Mod 2023/0617
5 Skyline Place, Frenchs Forest – Stage 2
Proposed Modifications to Approved DA2021/0212 Development
Servicing Matters

I refer to Council's recent Traffic and Waste internal referral responses, requesting additional information in respect of the abovementioned modification application. The following advice is provided in respect of the matters raised by Council's Traffic and Waste officers.

Figure 1 – Bin tug with trailer example

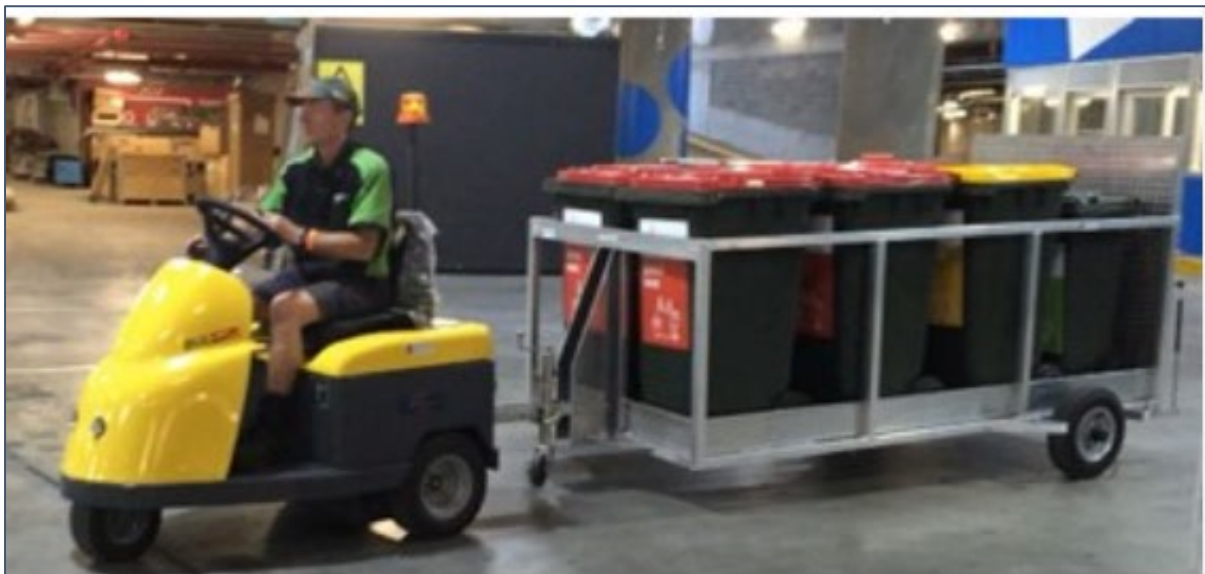
The current proposal has now removed both the waste bin lift and the waste ramp access to/from the basement. The vehicular driveways are not to be used for the process of transferring bins between the basement rooms and street level bin servicing area. The potential conflict between vehicles exiting the basement and the operation of a bin tug on the driveway ramp is unacceptable.

For the bin tug the access the waste servicing area it would be required to perform a 180 degree turn on the public footpath/road outside the property. This is also unacceptable. As the driveway ramp adjacent to the waste servicing area is shown as "exit only" please advise how the bins will be returned to the basement rooms. It is Councils' expectation that the public road and footpath not be used for this purpose. All bin movements are to be contained within the property.

Whilst a specific bin transfer vehicle has not yet been chosen, there are a number of options on the market. Two of the more suitable options are shown in the following images.

The proposed bin transfer procedure between the basement storage room and the temporary holding area adjacent to the loading bay is as follows:

- Bin tug & trailer/bin utility vehicle kept within residential garbage room 2 when not in use,
- Prior to specified waste collection times, bins are loaded into/onto the bin tug & trailer/bin utility vehicle within residential garbage rooms 1 & 2, and transferred up to the temporary holding area,
- Before returning to the basement with the vehicle to collect more bins, the contractor will press a button located within the at-grade loading bay which will activate a red traffic signal at the bottom of the ramp in the basement, instructing exiting drivers, if any, that they must Wait On Red – i.e. until the signal turns back to green,
- The bin tug & trailer/bin utility vehicle returns to the basement garbage rooms to collect more bins and repeats the process,
- The opposite procedure occurs when transferring emptied bins back to the basement bin rooms.

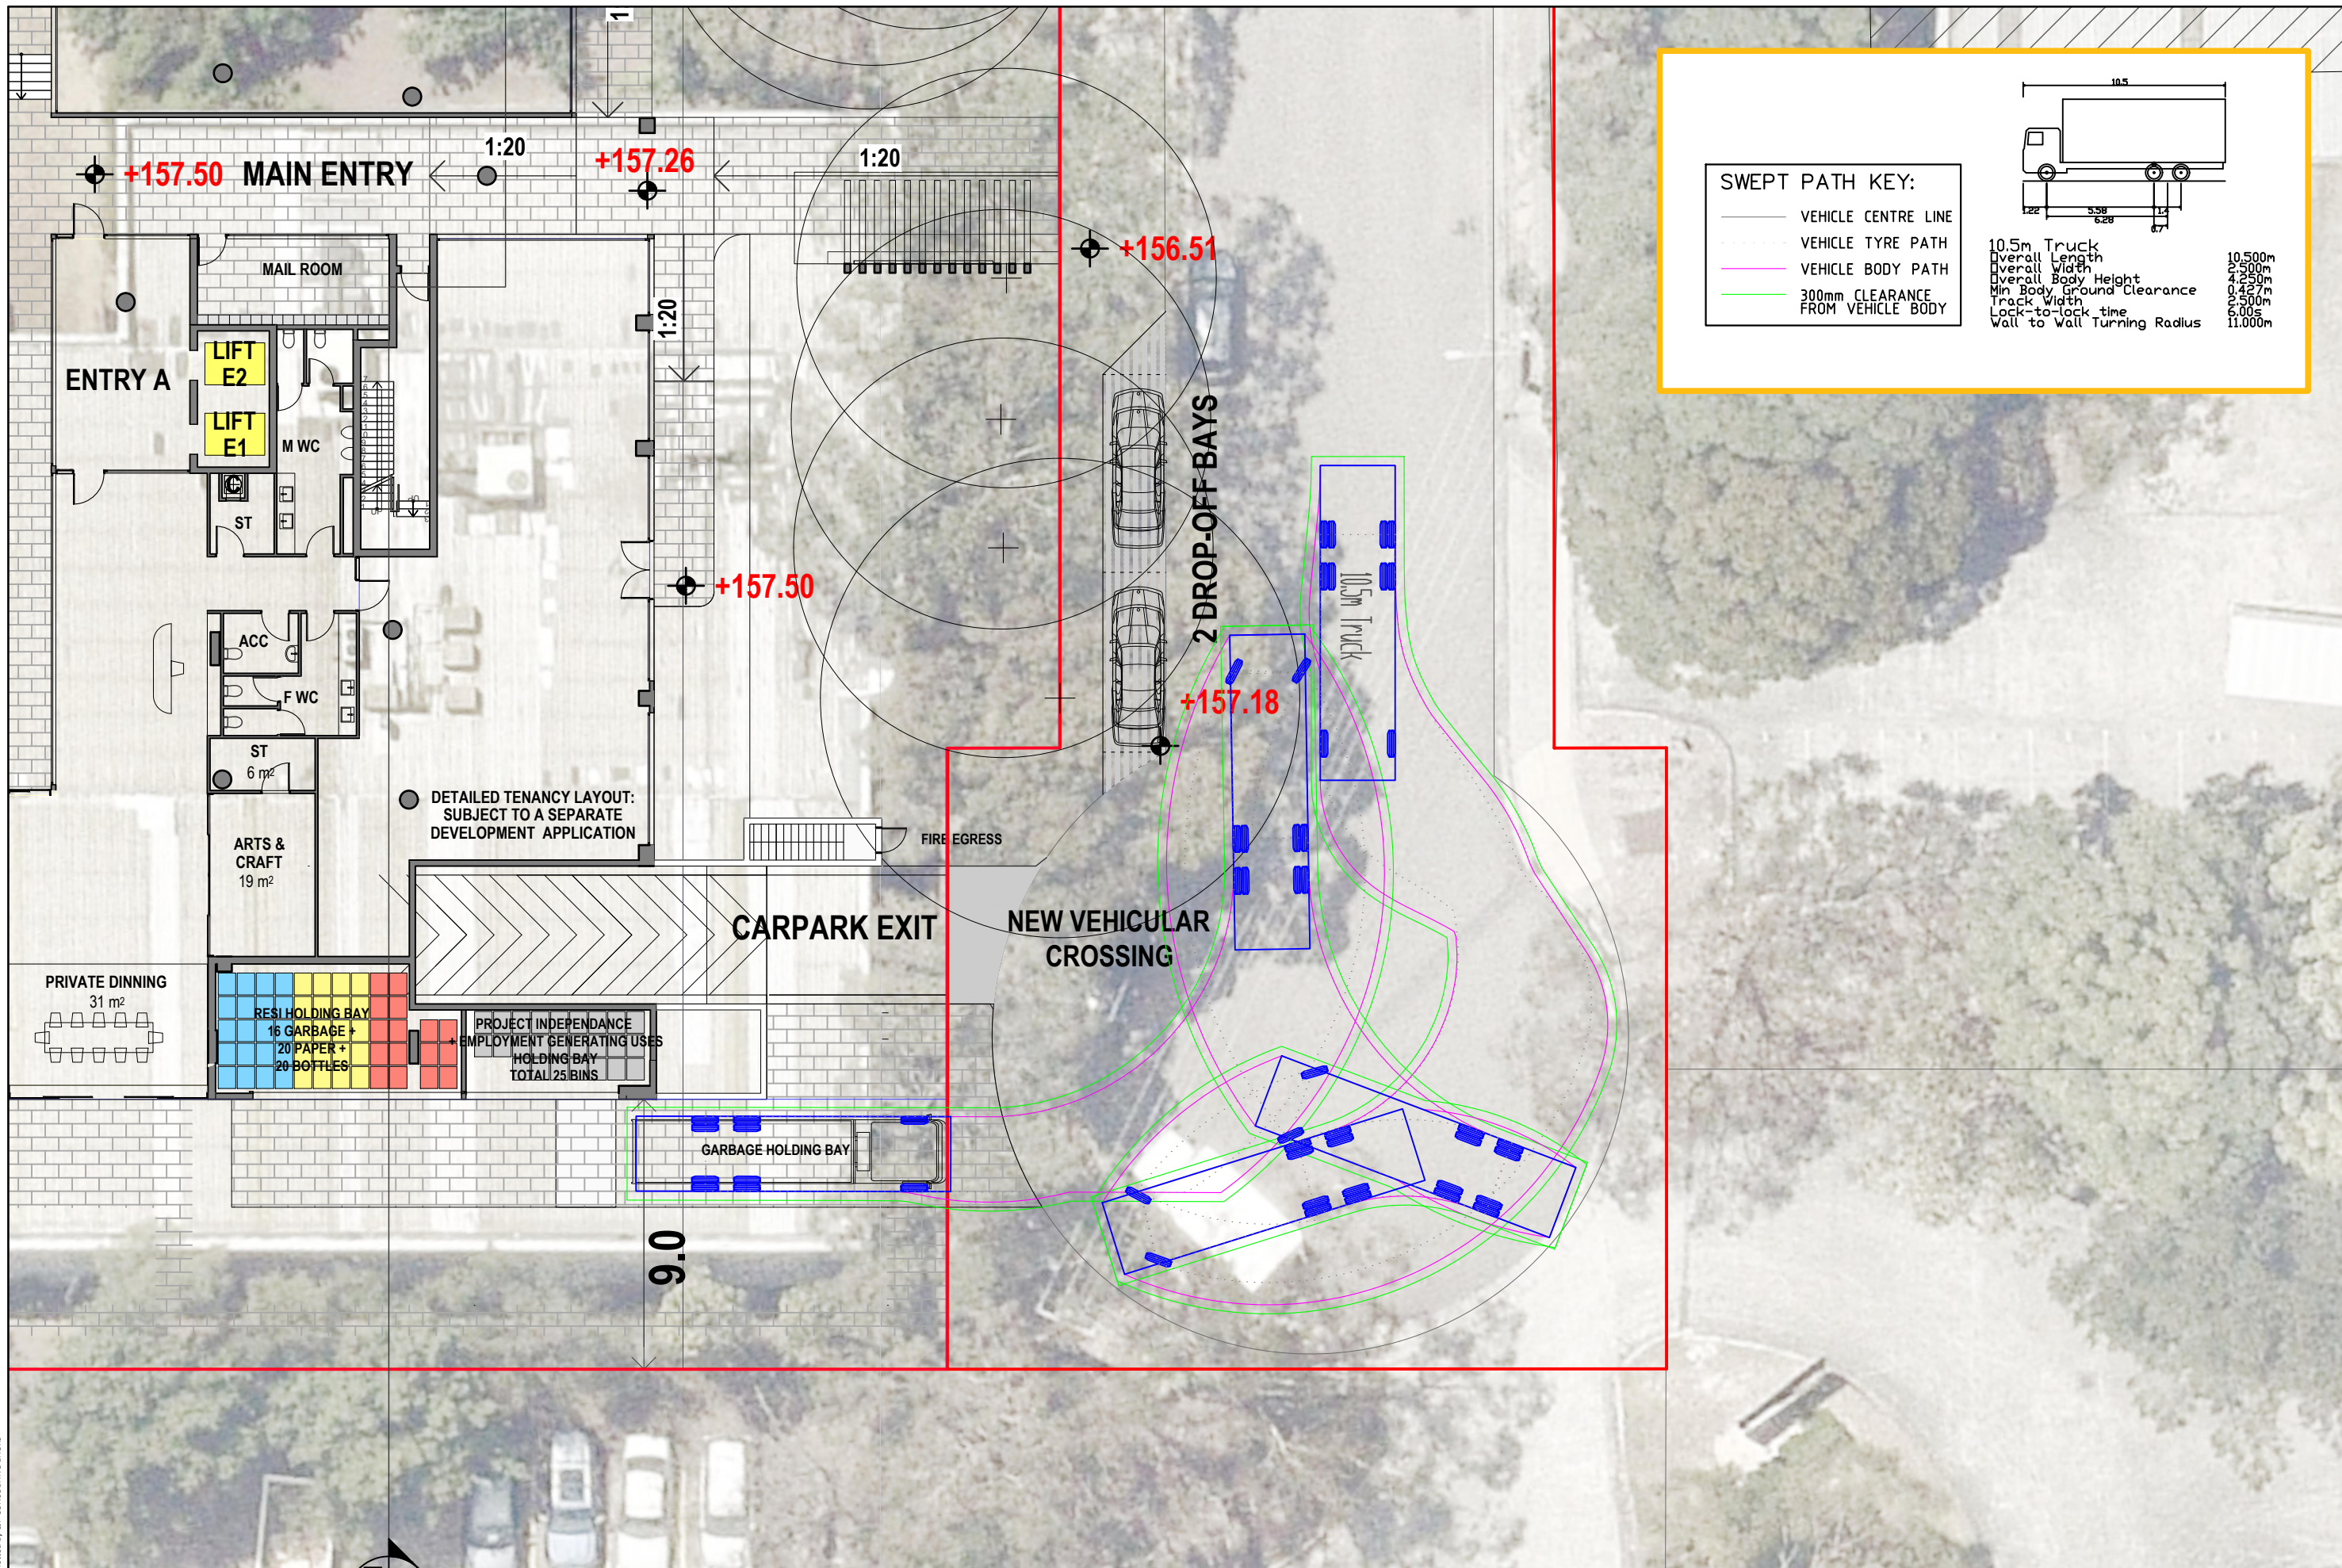
It is noted that Council's waste services team have raised concerns about the changes made to the access arrangements to the street level bin storage areas. It is noted that the dimensions of the dock area have also been reduced with access to the bay now more constrained. Swept path plots must be provided to demonstrate that ingress and egress for Council's 10.5m long Waste Services truck can be achieved.

With respect to Council's waste service vehicle, please see attached swept turn path diagram of a 10.5m long truck performing a u-turn manoeuvre within the Skyline Place cul-de-sac turning head, before reversing into the on-site loading bay. It is also pertinent to note that this is the same manoeuvre that was approved by Council under the original DA2021/0212 scheme, albeit with a modified loading bay design.

Note, the top of the car park exit ramp will be relatively level with the area adjacent to the loading bay, such that there will not be a ramp kerb and the bin tug & trailer/bin utility vehicle will *not* need to exit the site boundary in order to move between the ramp and the temporary bin holding area.

In lieu of a ramp kerb, other measures such as removable bollards may be considered, which the waste contractor removes for a short period of time in order to undertake the bin transfers. The bollards would then be returned once the bin transfers are complete.

It is also recommended that a “No Entry – Waste Utility Vehicle Excepted” sign is installed at the top of the car park exit driveway, facing outwards to the street.
